RAI 02.04.04-9, Supplement 1, Part A:

The following changes will be made to COLA, Part 2, Tier 1, Section 5.0, Tier 2 Subsections 2.0, 2.4S.1, 2.4S.2, 2.4S.4, 2.4S.6, 2.4S.10, 2.4S.14, 2.5S.5, 3.4, and 3H, and COLA Part 7, Subsection 2.1, to incorporate the revised main cooling reservoir (MCR) embankment breach analysis as described in the responses to RAI questions 02.04.04-9 and 02.04.04-10.

Supplement 1, Part B, to RAI 02.04.04-9 Response:

Figure 2.4S.4-19: Locations for RMA2 Modeling Results

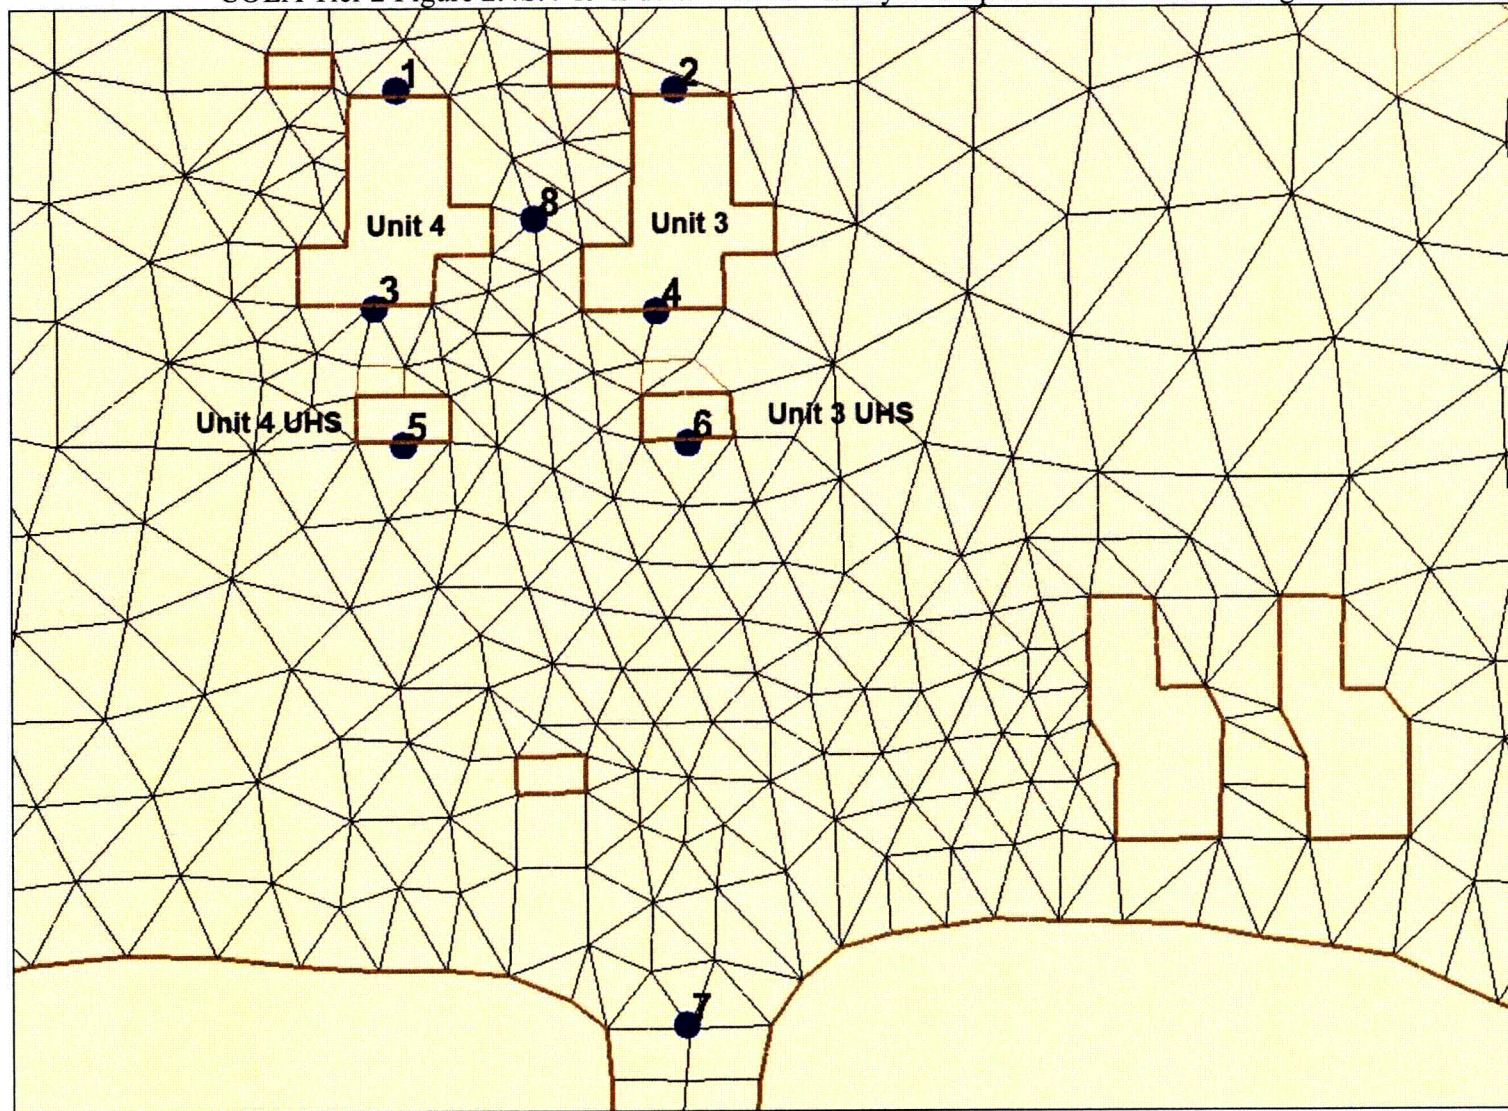
Critical STP 3 and 4 site locations for RMA2 model results are shown on Figure 2.4S.4-19. The variation in water surface elevation at these locations from 1.2 hours to 2.5 hours of the model simulation are presented in Figures 2.4S.4-20 and 2.4S.4-21 for the east breach and west breach, respectively. This selected period includes the peak water level and peak velocity near the plant buildings. The peak water level of 38.8 feet occurred at the Unit 4 Ultimate Heat Sink structure for the west breach scenario. Peak water surface elevations for the east breach and west breach are shown on the plan grid in Figures 2.4S.4-21(a) and 2.4S.4-21(b), respectively. Peak velocities associated with the east breach and west breach are shown in Figures 2.4S.4-21(c) and 2.4S.4-21(d), respectively. The maximum velocity of the flood flow was found to be 4.72 feet per second and occurred between Units 3 and 4 (point 8 on Figure 2.4S.4-19). The variation in velocity at locations 1 through 8 for the period containing peak velocities for the east and west breach scenarios is shown in Figures 2.4S.4-21(e) and 2.4S.4-21(f), respectively.

COLA Tier 2 Figure 2.4S.4-19 is deleted in its entirety and replaced with the following:

Figure 2.4S.4-20: Time-Dependent Water Surface Elevations Associated with East Breach Scenario

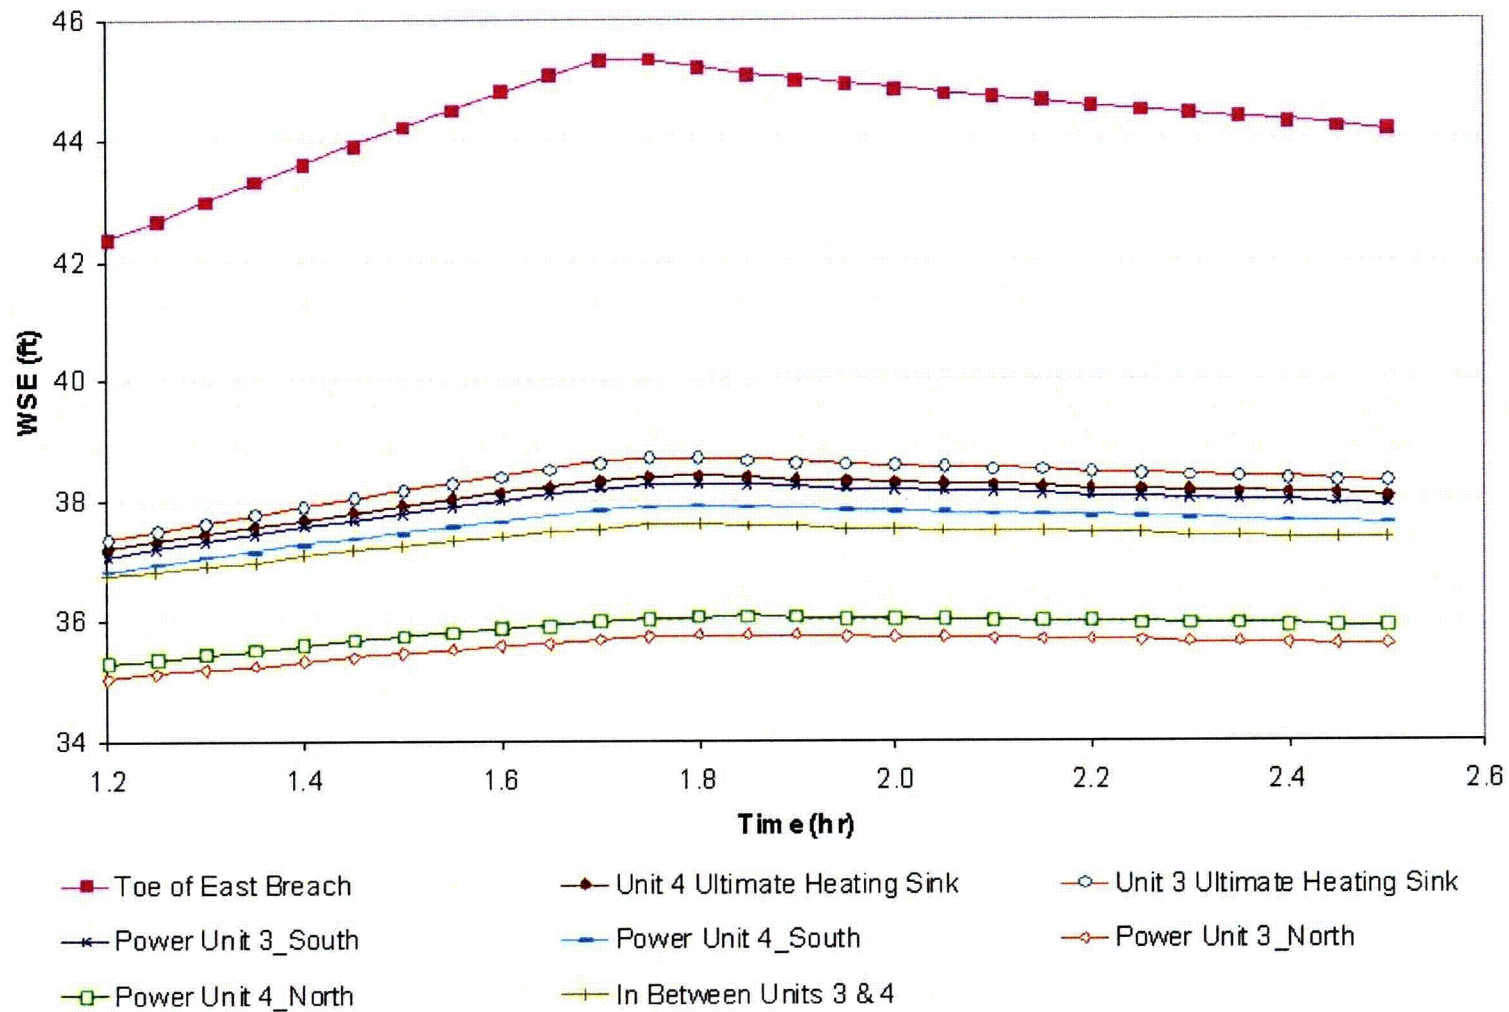
COLA Tier 2 Figure 2.4S.4-20 is deleted in its entirety and replaced with the following:

Figure 2.4S.4-21: Time-Dependent Water Surface Elevations Associated with West Breach Scenario

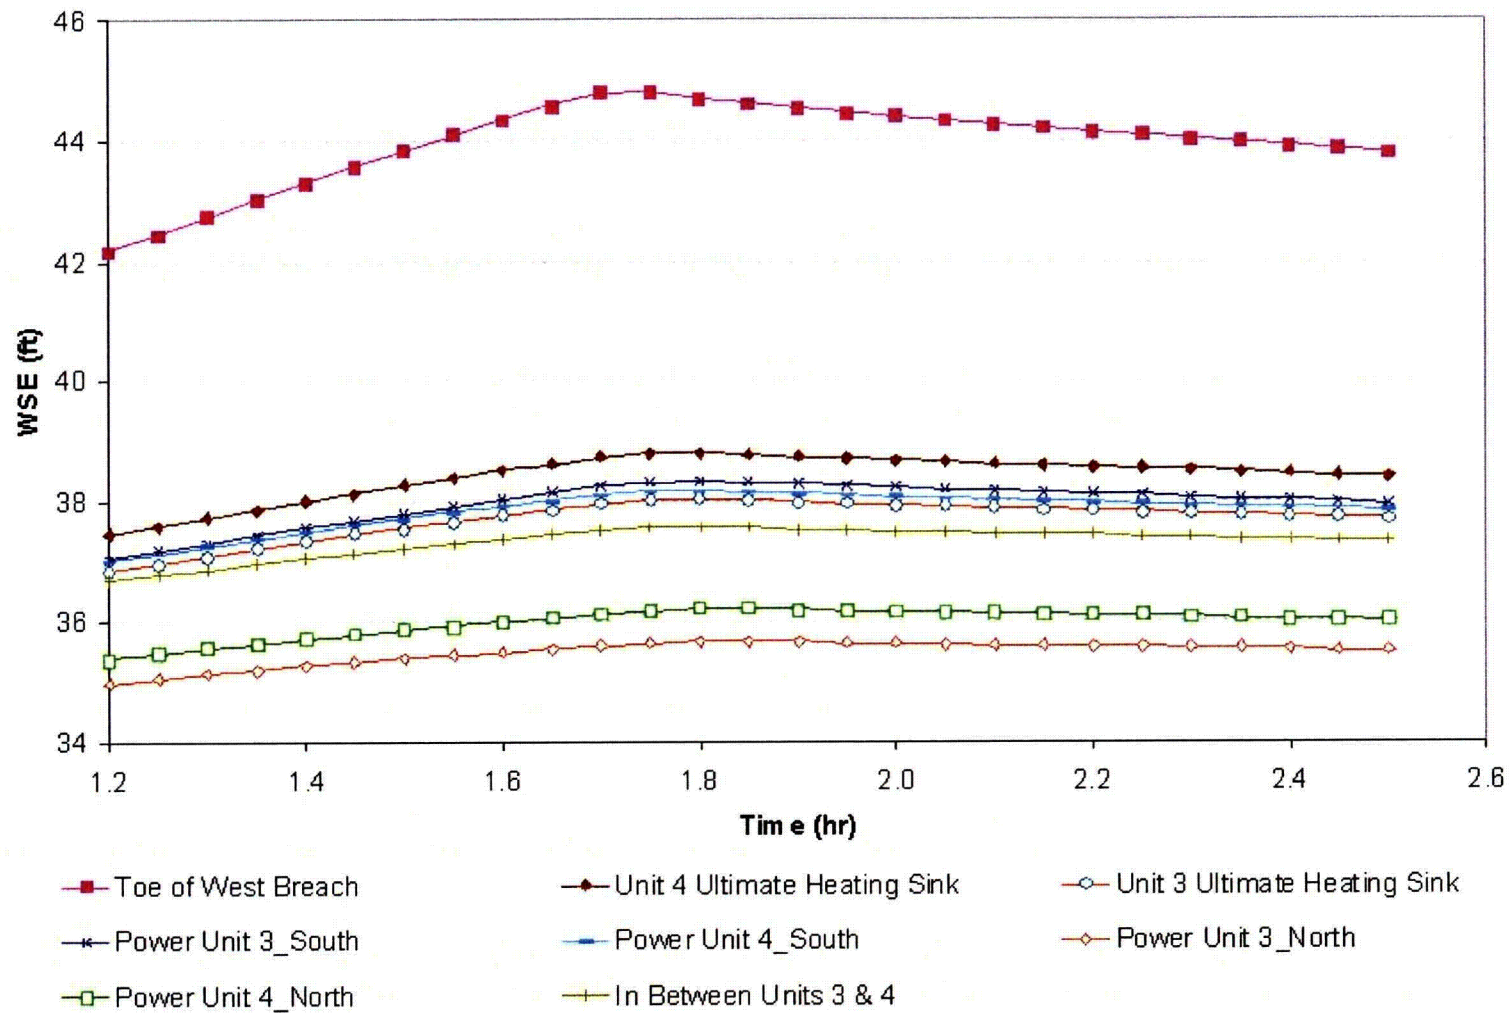
Figure 2.4S.4.21 details the time history of the simulated flood level at the southern face of the STP 3 & 4 UHS. As indicated in the figure, the flood wave arrives at the building in about 1.25 minutes after the embankment breaches, and a quasi-steady state flow regime is sustained for about 15 minutes (between 4 and 19 minutes after the embankment breach). Thereafter, the flood level drops because of the receding storage volume and water level in the MCR.

COLA Tier 2 Figure 2.4S.4-21 is deleted in its entirety and replaced with the following:

Figure 2.4S.4-21(a): Peak Water Surface Elevations Associated with East Breach Scenario (at time = 1.75 hours after initiation of breach)

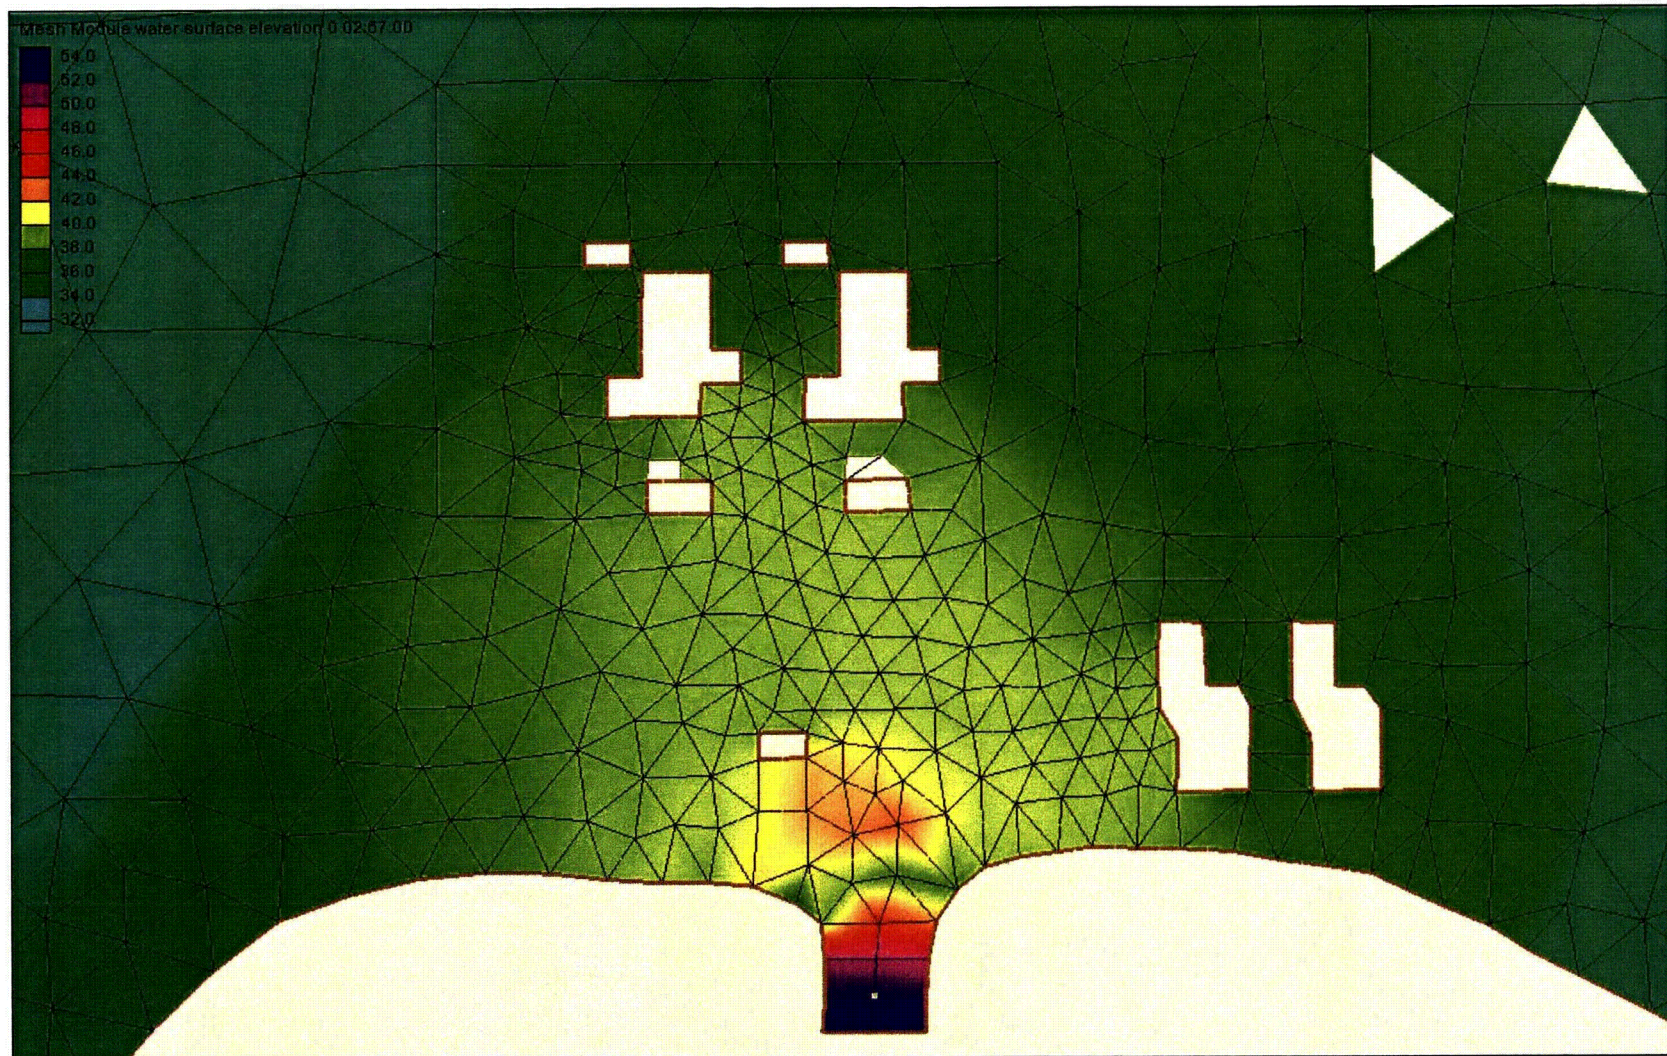
COLA Tier 2 Figure 2.4S.4-21(a) is a new figure:

Figure 2.4S.4-21(b): Peak Water Surface Elevations Associated with West Breach Scenario (at time = 1.75 hours after initiation of breach)

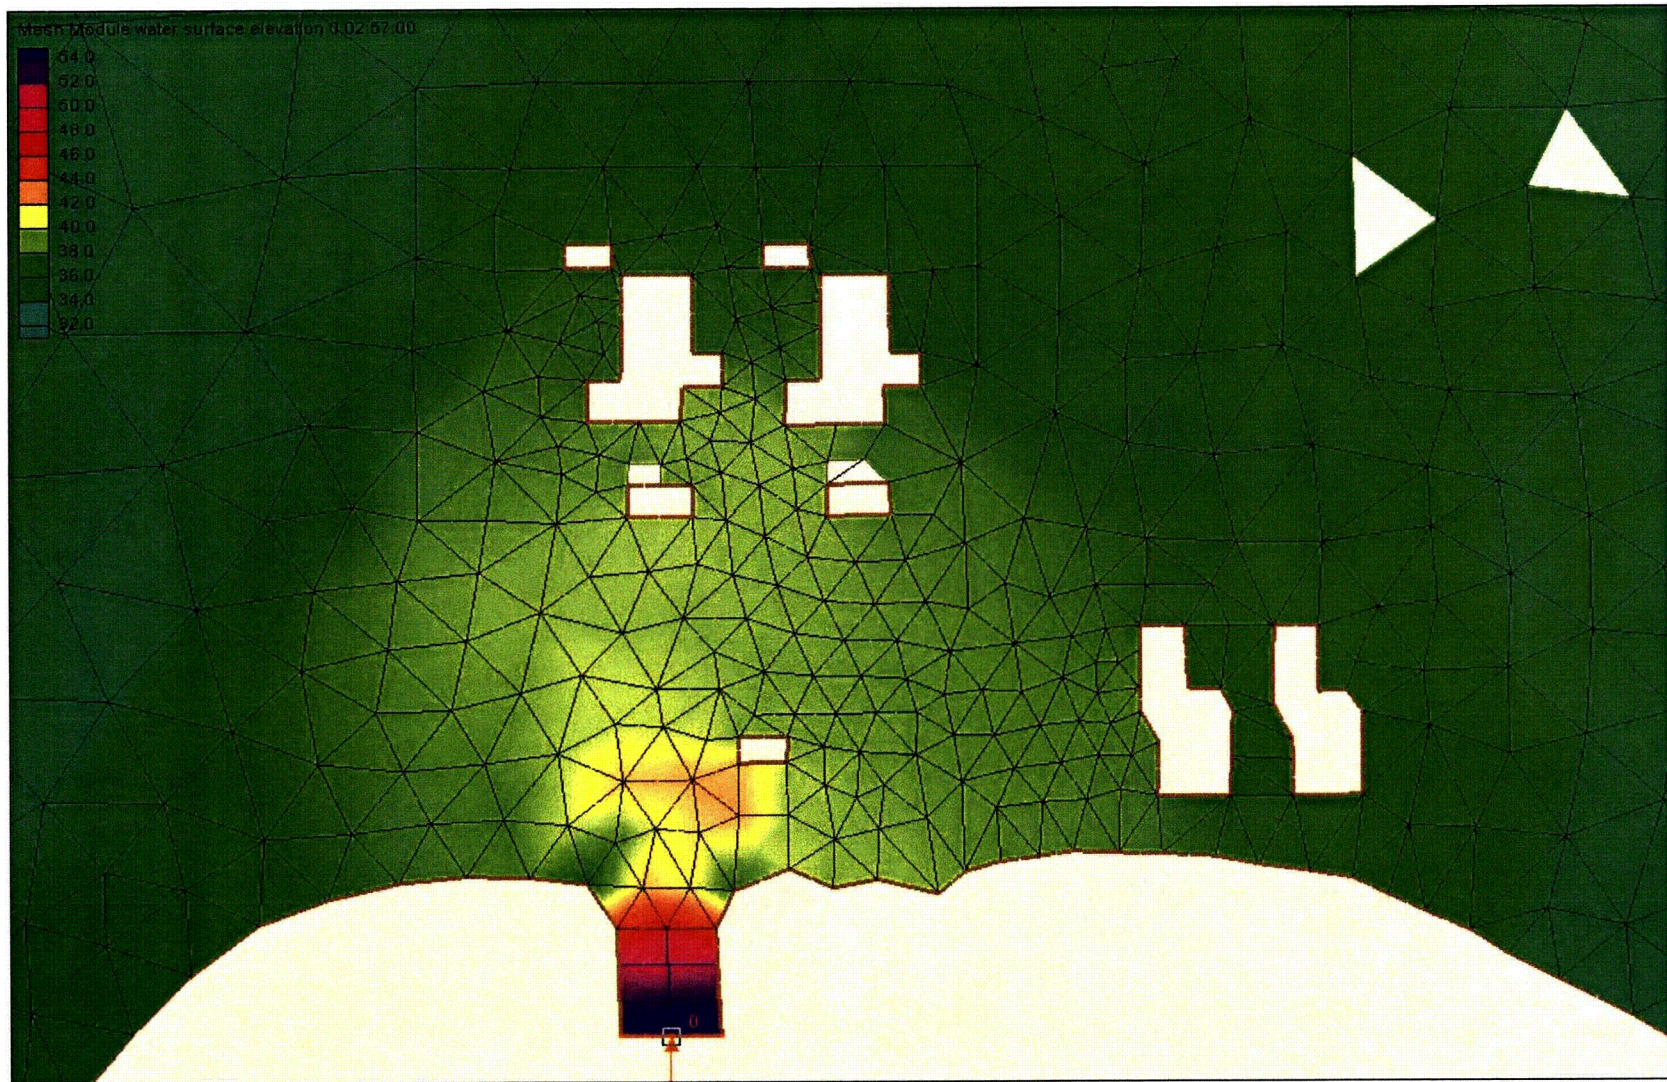
COLA Tier 2 Figure 2.4S.4-21(b) is a new figure:

Figure 2.4S.4-21(c): Peak Velocities Associated with East Breach Scenario (at time = 1.75 hours after initiation of breach)

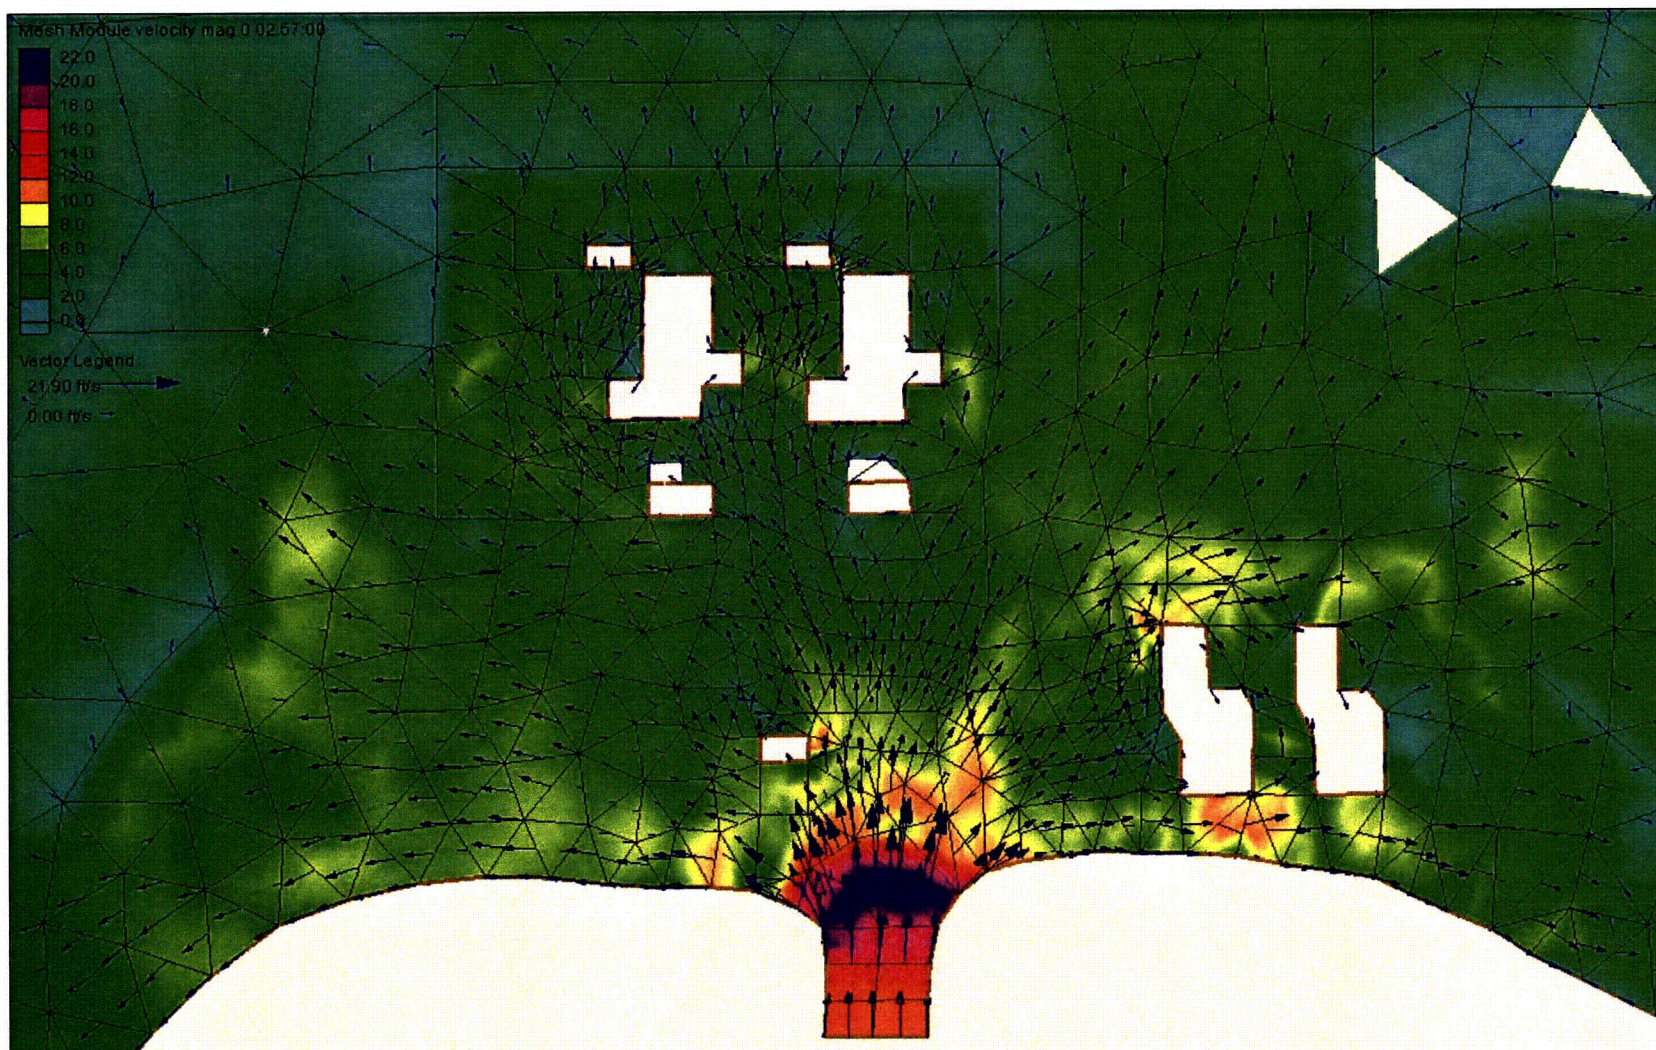
COLA Tier 2 Figure 2.4S.4-21(c) is a new figure:
